Access Compliance Report Public Rights-of-Way (Curb Ramps)

Intersection ID: 45829 Main Street: PATRICIA_ANN_LN Cross Street: CHRISTENBURY_HILLS_LN Location: SE

ADA ID: 498FA0A5D694 Ramp Type: Perp Initial Pass/Fail: Fail Overall Compliance: No Severity Score: 26.25

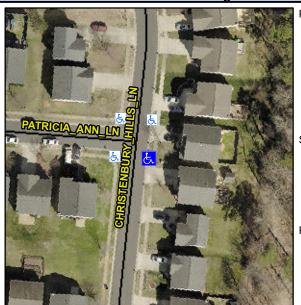
Field Measurements/Component Compliance								
Comp	liance Description	Data	Comp	liance Description	Data			
N/A	Ramp Length (in)	47.5	No	Ramp Slope (%)	16.5			
Yes	Ramp Width (in)	52.0	No	Ramp XSlope (%)	2.8			
N/A	Flare Type LT	N/A	N/A	Flare Type RT	N/A			
N/A	Flare Slope LT (%)	N/A	N/A	Flare Slope RT (%)	N/A			
N/A	Flare Traversable LT?	N/A	N/A	Flare Traversable RT?	N/A			
N/A	Landing Length (in)	N/A	N/A	DWS Provided?	N/A			
N/A	Landing Width (in)	N/A	N/A	DWS Contrast?	N/A			
N/A	Landing Slope (%)	N/A	N/A	DWS Length (in)	N/A			
N/A	Landing X Slope (%)	N/A	N/A	DWS Full Width?	N/A			
N/A	Landing Curb? (Y/N)	N/A	N/A	DWS Offset (in)	N/A			
N/A	Shared Landing?	N/A						
N/A	Gutter Ponding?	N/A	N/A	Gutter Slope (%)	N/A			
N/A	Gutter Lip Ht (in)	N/A	N/A	Gutter X Slope (%)	N/A			
N/A	Painted X Walk1?	No	N/A	Painted X Walk2?	N/A			
	X Walk 1 Direction	To W		X Walk 2 Direction	N/A			
N/A	X Walk 1 Width (in)	N/A	N/A	X Walk 2 Width (in)	N/A

Possible Solution	
Possible Solutions:	Cor
Remove & Replace Entire Ramp.	N/A
·	Yes
	N/A
	N/A
	N/A
	N/A
Surveyor Notes:	N/A
N/A	N/A
	N/A
	N/A
	N/A
PROW/ADA:	N/A
R304.2.2, R304.5.3	N/A
,	N/A
	N/A
	NI/A
